## **Appendix 2**

### **Assessment of matters of national environmental significance under the *Environment Protection and Biodiversity Conservation Act 1999***

**for the Taraborah Coal Project**

**proposed by Shenhua International Group Pty Ltd**

**Figure 3-4 Conceptual west to east geological cross-section of the project site**

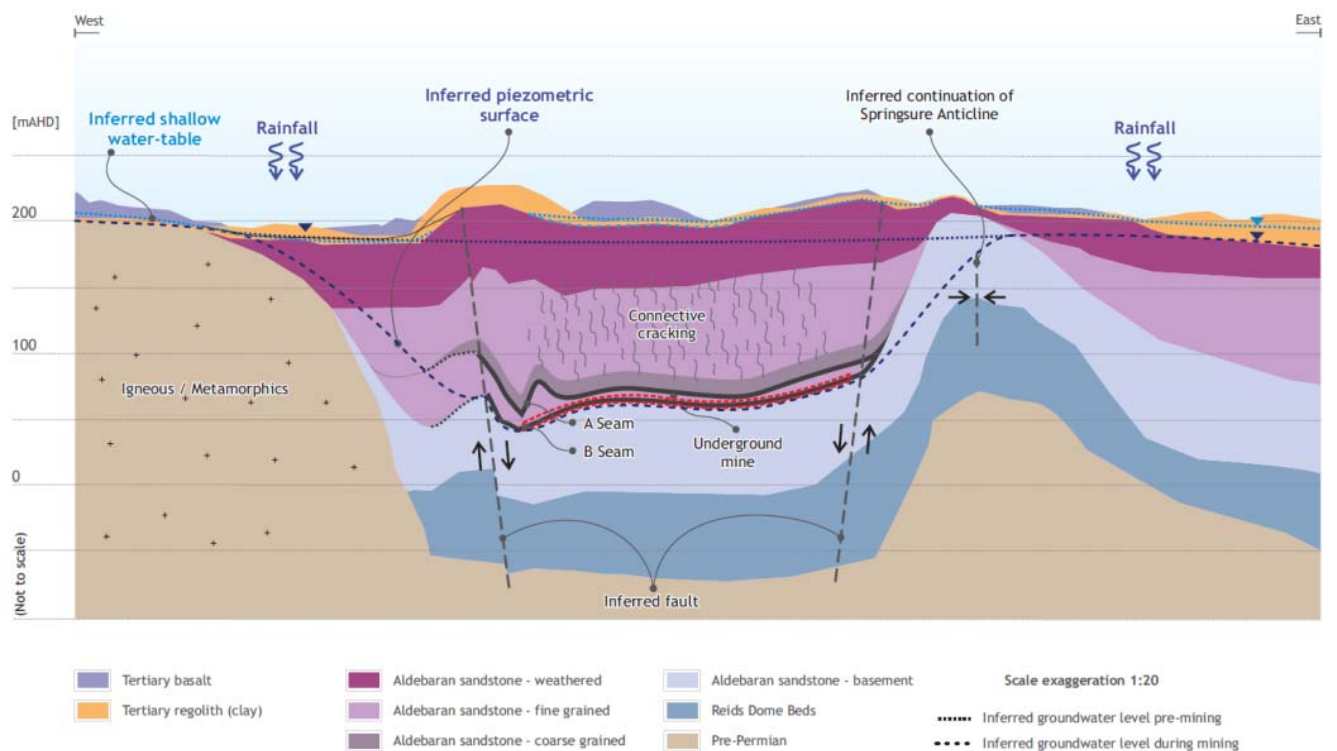
- the coal seams were simulated in the model to end where the strata gets shallower to the east and west, based on regional drilling data (see Figure 3-4 above)

Figure 3-5 Model of strata behaviour above full-extraction mining panels (Kendorski 1993)

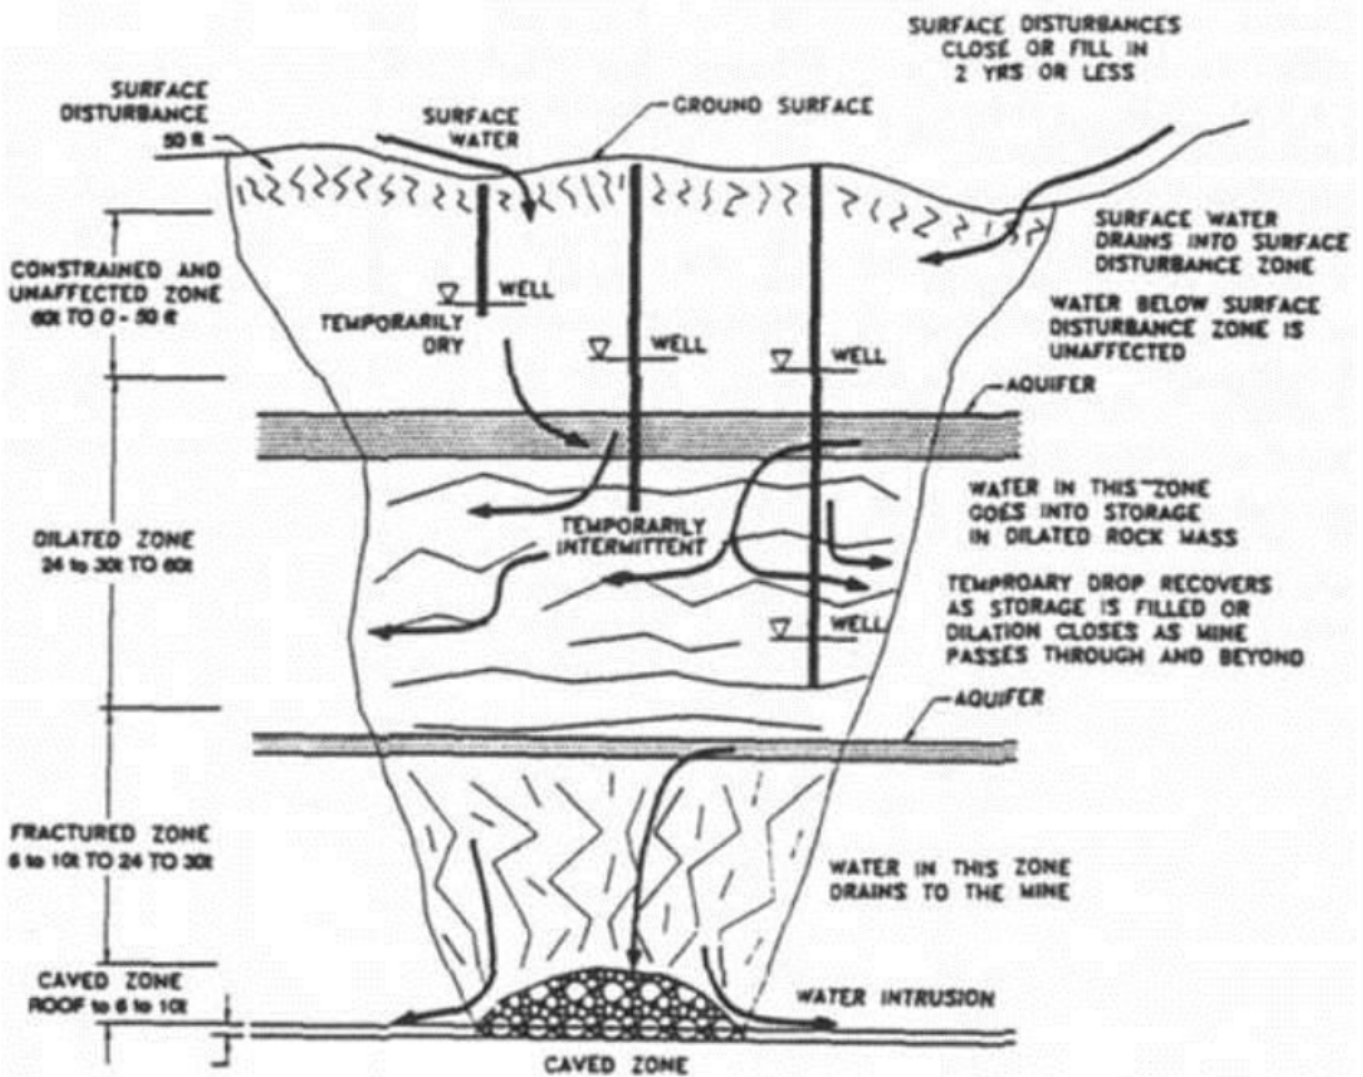
- apart from the typically recognised fractured zone of deformation above subsided mine workings, there also exists an overlying dilated zone, where the strata bend and are subject to bed separation, with limited vertical cracking that does not provide an effective vertical connection to the lower strata (Figure 3-5)

The proponent also conducted a sensitivity analysis, which indicated that the modelling was robust and the areal extent of the 1m drawdown contour does not substantially increase in response to the likely range of input parameters. DNRM was satisfied that the issue raised by the IESC has been adequately addressed.
